ADDENDUM No. One (1)

IFB NO. 10054-10

**Construction, Bridge: County Road 618 over Cedar Creek
and County Road 655 over Brushy Creek**

**Construction, Bridge: County Road 618 over Cedar Creek
and County Road 655 over Brushy Creek
Addendum No. 1**

QUANTITIES & TYPICAL SECTION

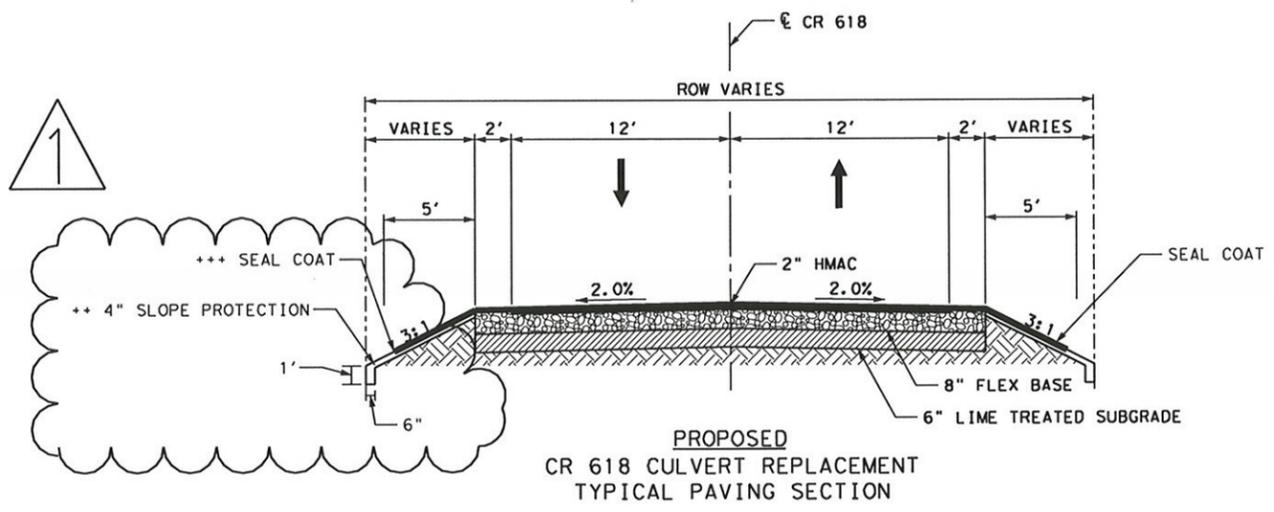
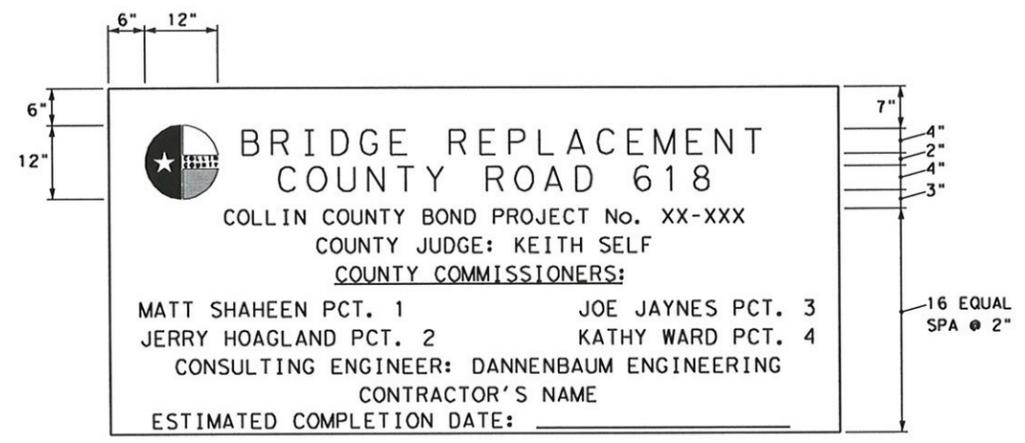
3. Erosion Control- For CR 618 add erosion control measures indicated on typical section (ps. 2) And plan and profile sheet (ps, 9)
4. Barricades – Plans indicate 2 months per location. This has been changed to 3 months per location.

NO.	DATE	REVISION	APP.
1	3-4-10	ADDED SLOPE PROTECTION AND QUANTITIES

**ALL DISTURBED AREAS SHALL BE SEEDED
 ** SLOPE PROTECTION TO BE A RE-BASE MATERIAL WITH MC-50.
 ***SEAL COAT TO BE MC-30 PRIME COAT

ROADWAY
PLAN & PROFILE

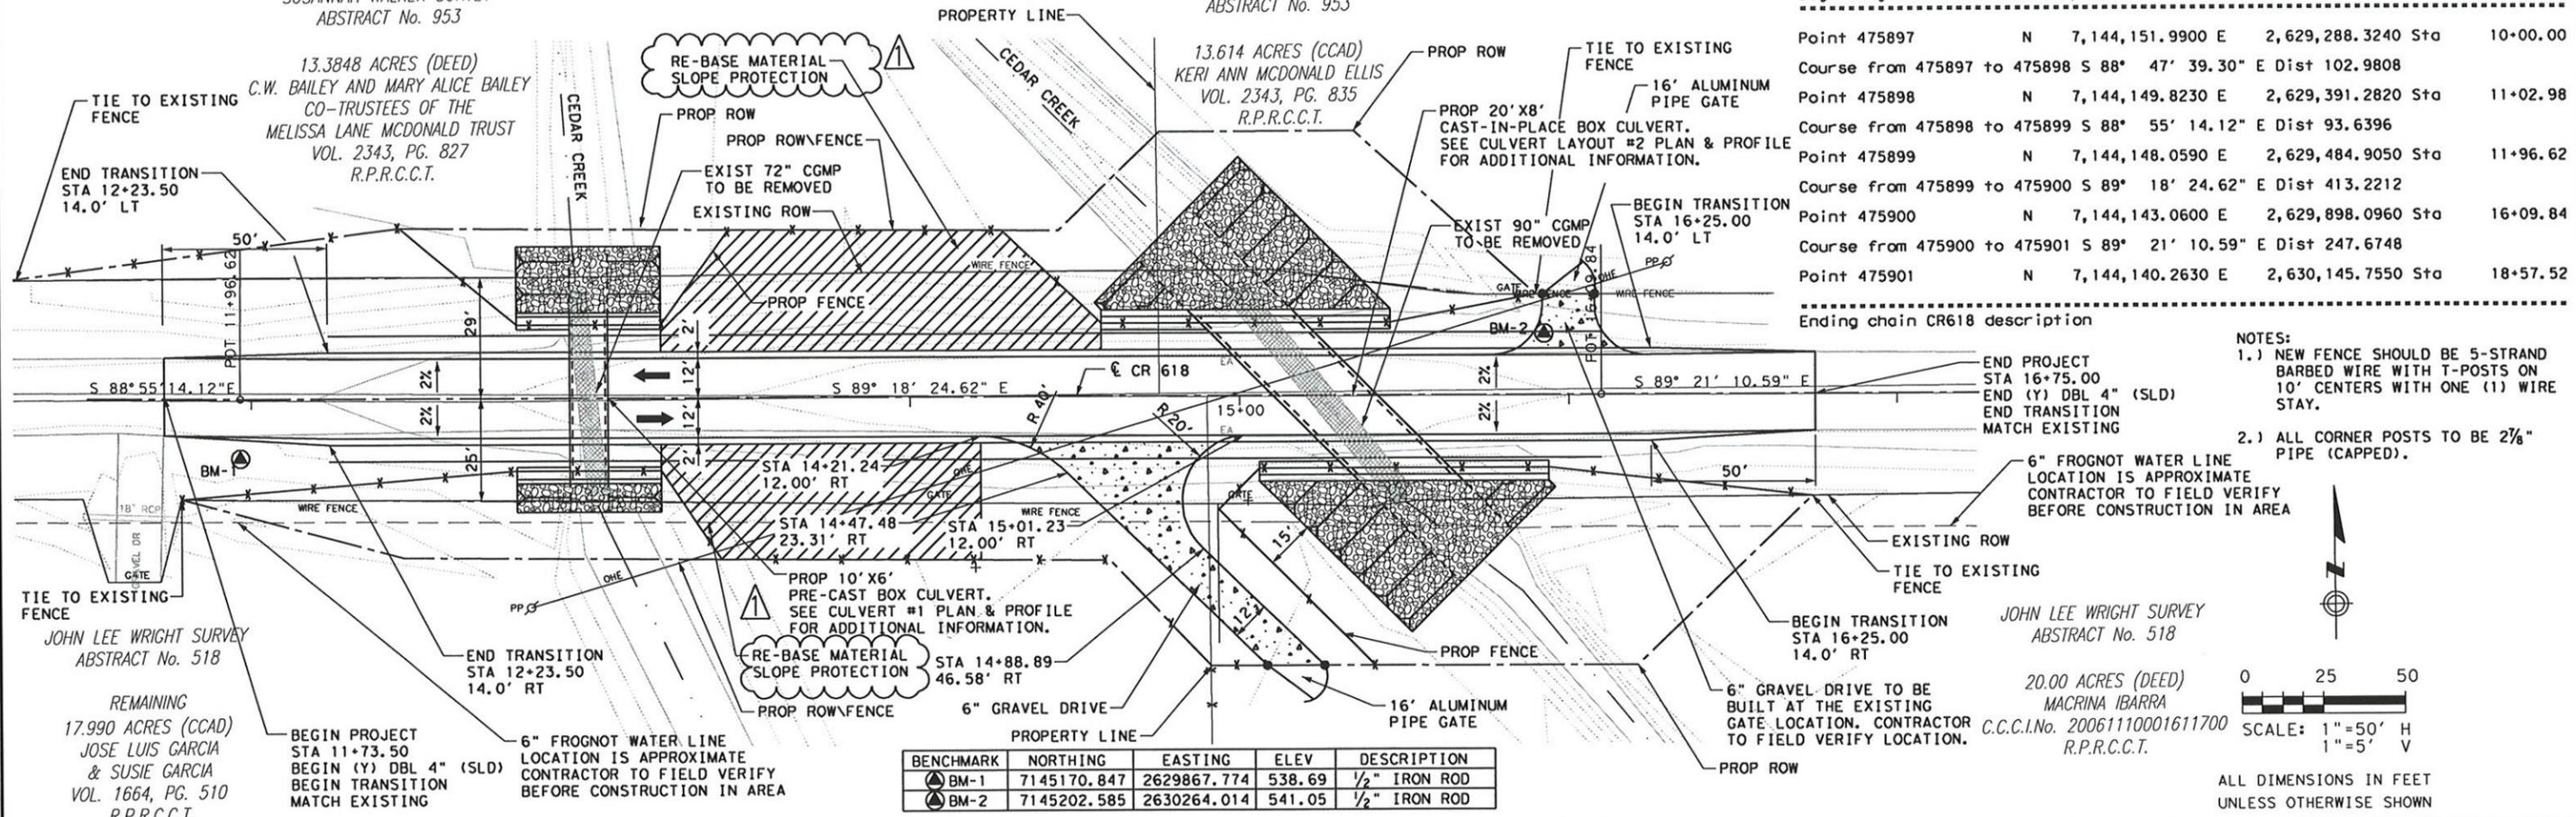
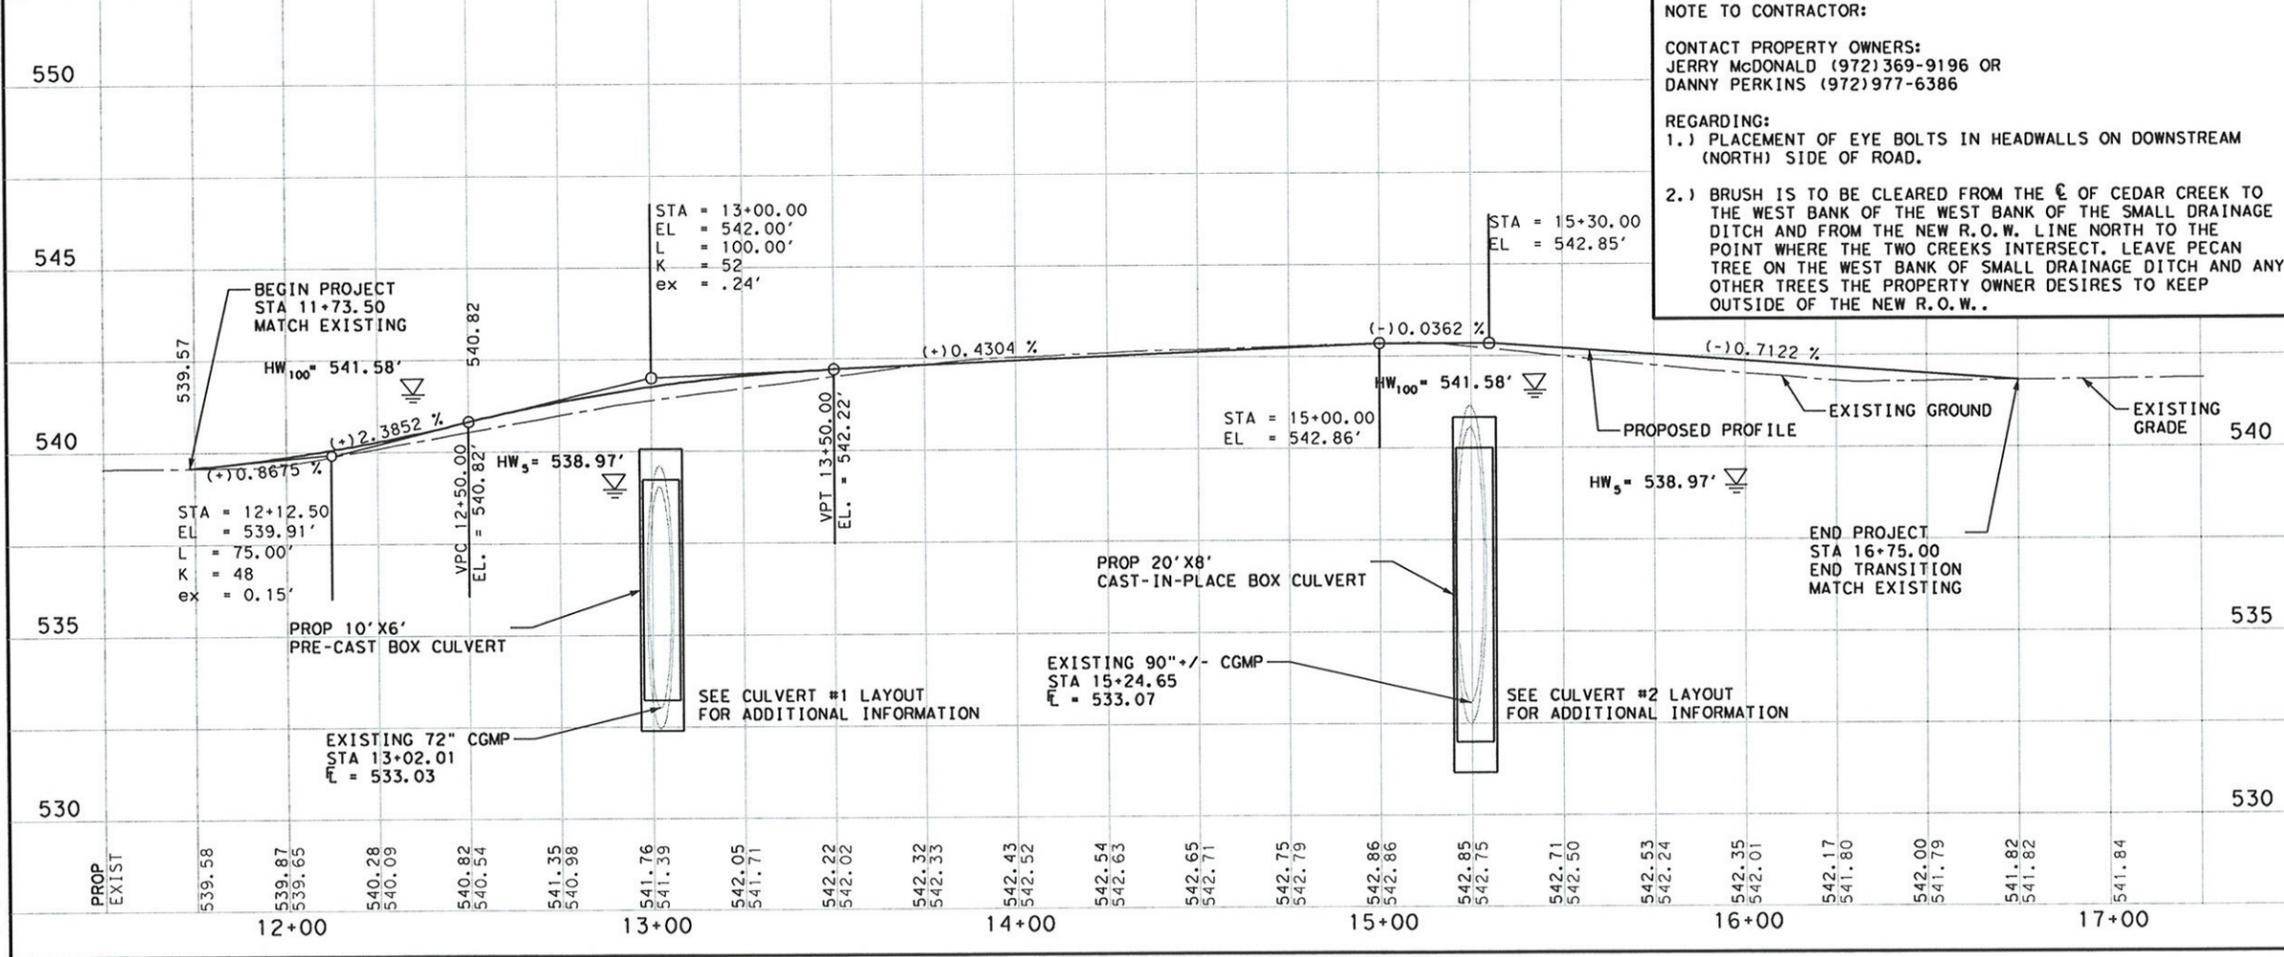
NO.	DATE	REVISION	APP.
1	3-4-10	ADDED SLOPE PROTECTION BETWEEN CULVERTS

QUANTITIES &
TYPICAL SECTION

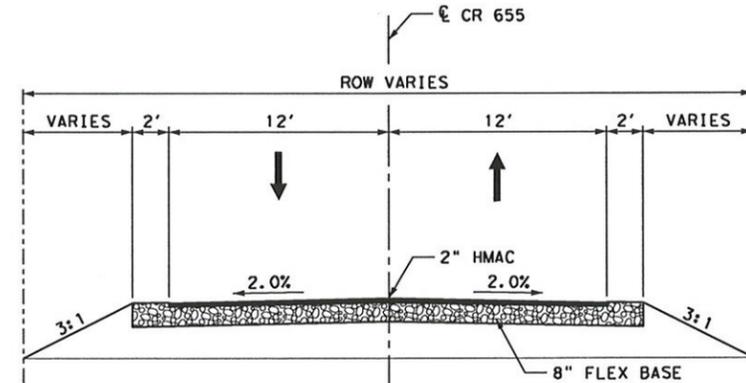
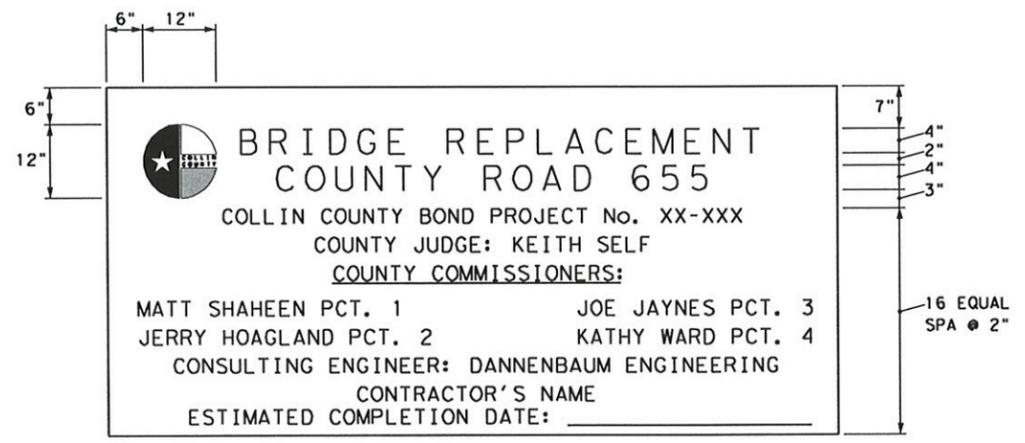
NO.	DATE	REVISION	APP.
1	3-4-10	ADDED SLOPE PROTECTION AND QUANTITIES

SINGLE BOX CULVERTS
 CAST-IN-PLACE
 MISCELLANEOUS DETAILS

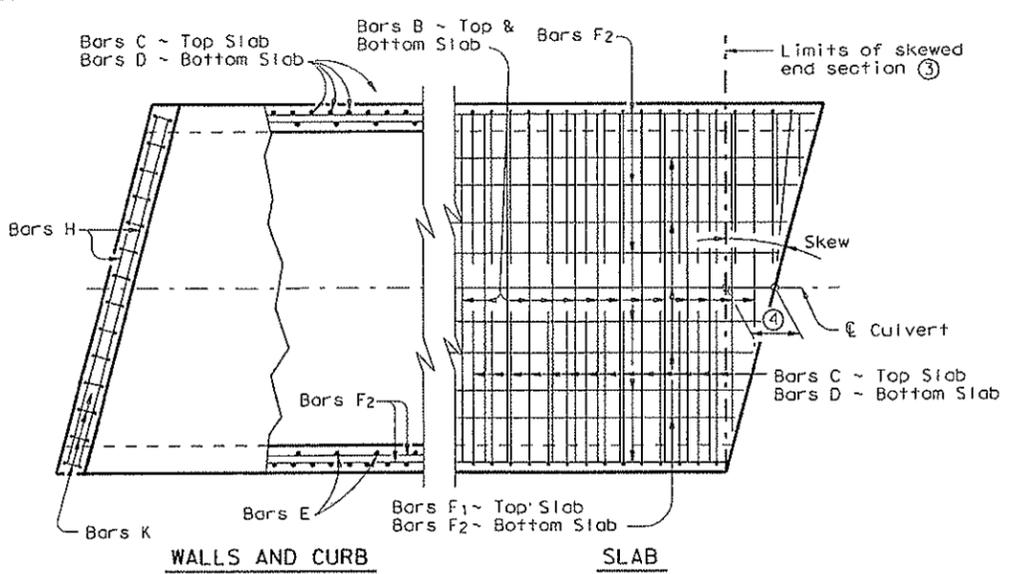
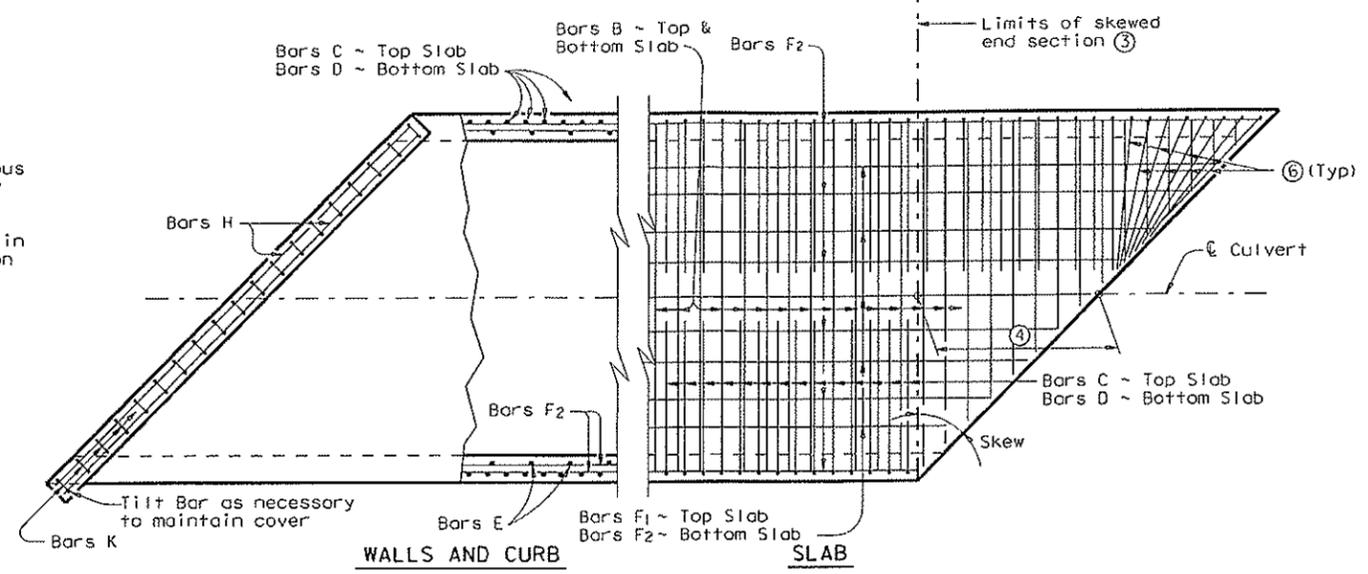
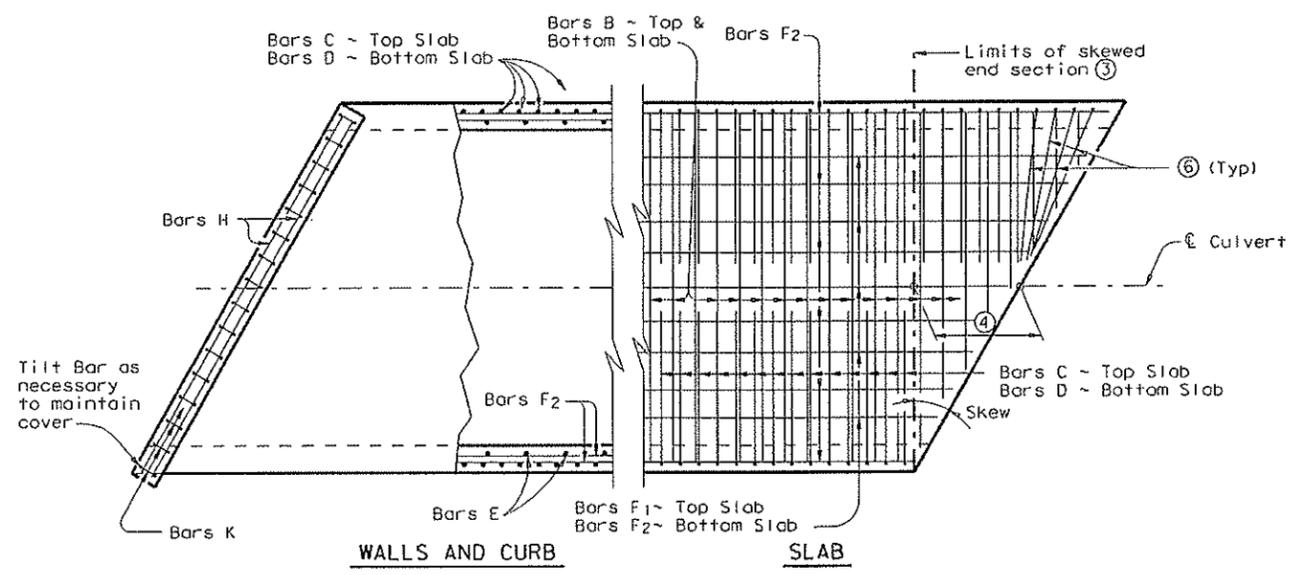
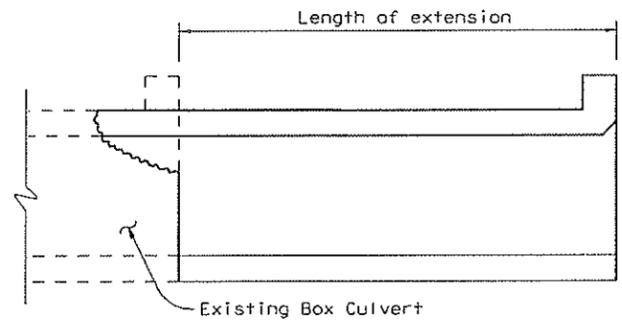
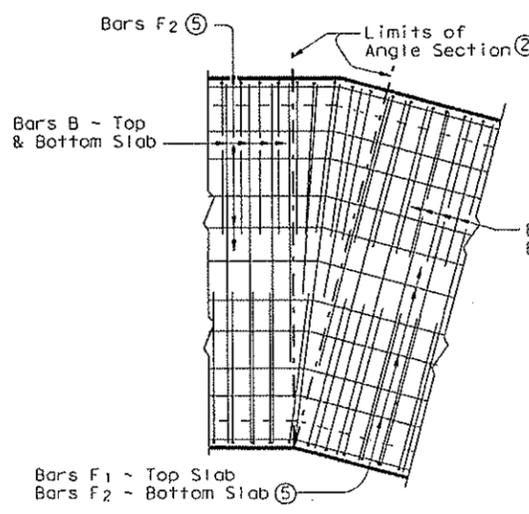
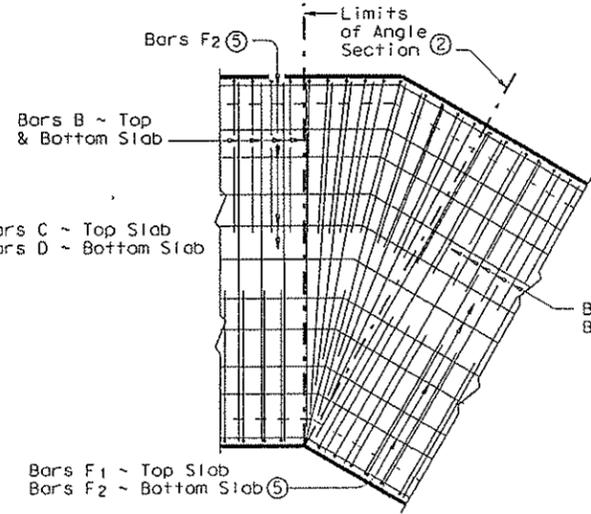
13. Adding standards to Plan sets as follow:

- a. CR 655: ps. 16A SCC-MD
 ps. 16B ECD
- b. CR 618: ps. 19A SCC-MD
